# SUBDIVISION REPORT - CONCEPT/DEVELOPMENT PLAN

▶ **FILE #:** 3-SC-26-C  
3-G-26-DP

▶ **SUBDIVISION:** BUTTERMILK ROAD

▶ **APPLICANT/DEVELOPER:** BALL HOMES, LLC

**C2.01**  
 CONCEPT PLAN  
 01/15/26

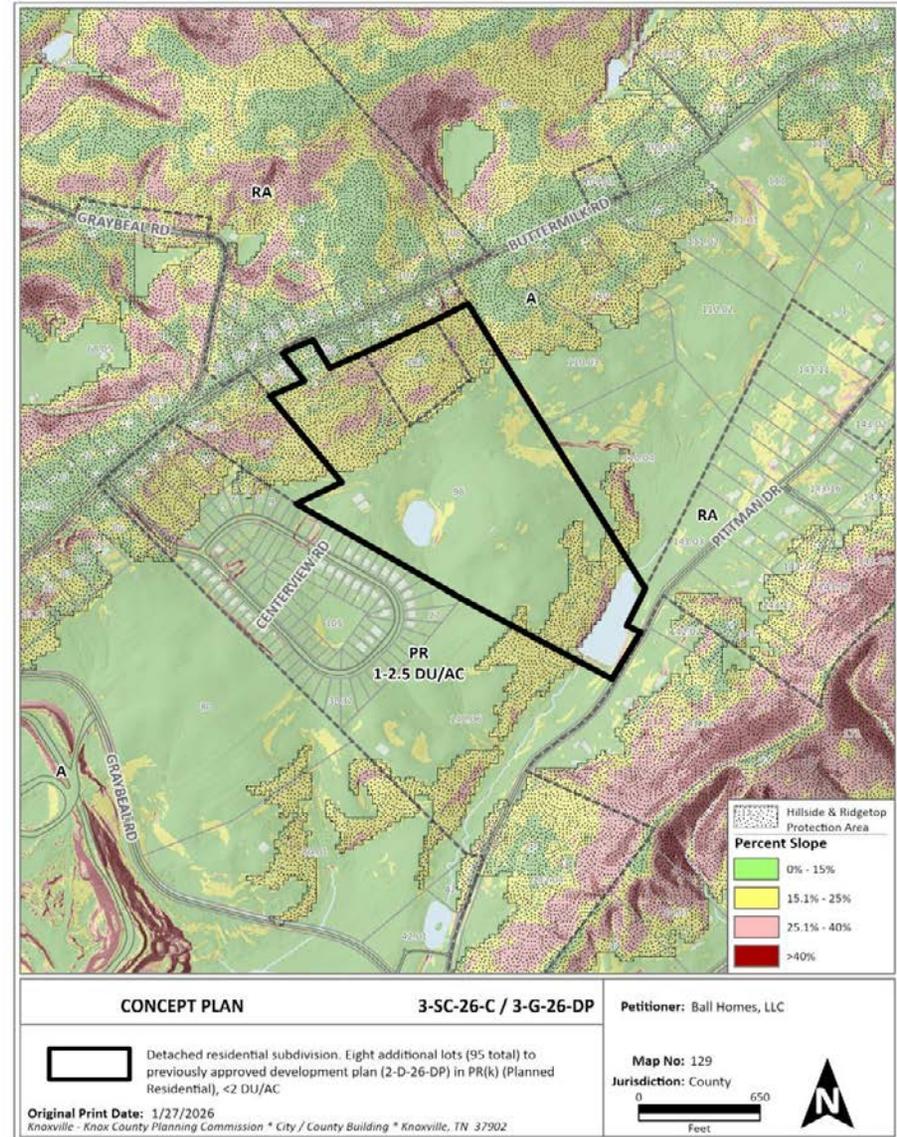
**HILLSIDE PROTECTION**  
 HILLSIDE PROTECTION AREA = 16.97 AC  
 DISTURBED HILLSIDE PROTECTION AREA = 6.41 AC  
 PERCENT DISTURBED HILLSIDE PROTECTION AREA = 37.77%
